INITIAL FIRE SAFETY INSPECTION REPORT

Factory Name: Fakir Eco-Knitwears Ltd.

RSC ID: 24934

Date: 14 January 2024

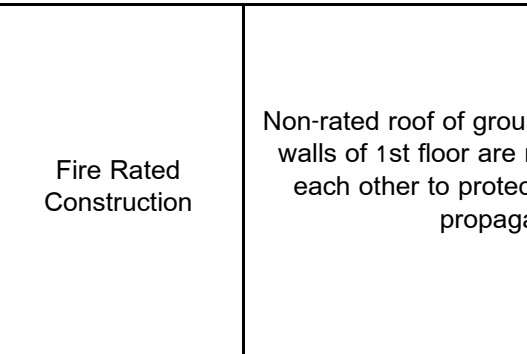
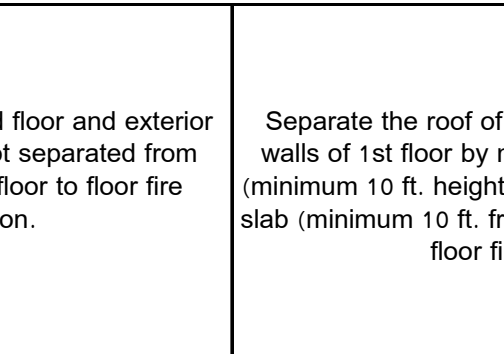
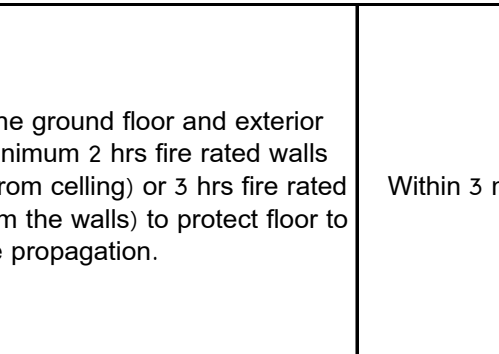
F-3	Fire Rated Construction	1. Elevator shafts are directly open into the inside of floor area on all floors except on ground floor. 2. Elevator shafts are directly open into the inside of exit enclosure on ground floor. Location: Building 1	Modify the elevator shaft as per RSC Technical Guideline (Standard) V1-6.14.3. Elevator shaft shall be 2-hr fire rated opening protection from factory floor. An exit stairway shall not be built around a lift shaft unless both of them are located in a smoke proof enclosure and made of a material with fire resistance rating required for the type of construction of smoke proof enclosure. So, ensure the lift shaft is 2-hr fire rated including opening protection with similar rating.	Within 6 months

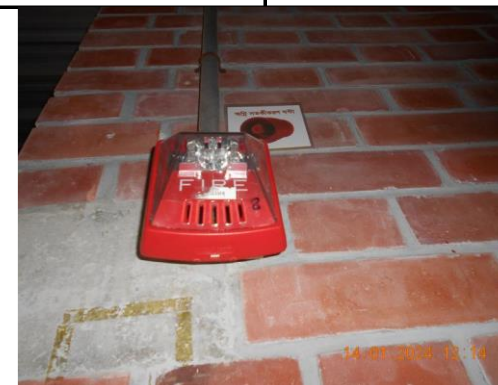
F-9	Means of Egress	The exit discharge path serving exit stair is less than 10 ft. wide and is not separated from the building interior. Location: Stair-3 of Building 1 on ground floor.	The building exterior walls within 3050 mm (10 ft) horizontally of a non-rated wall or unprotected opening shall have a fire--resistance rating of not less than 2-hr and the rating of the exterior wall shall extend 3.05 m (10 ft.) beyond the ends of the stair structure.	Within 3 months
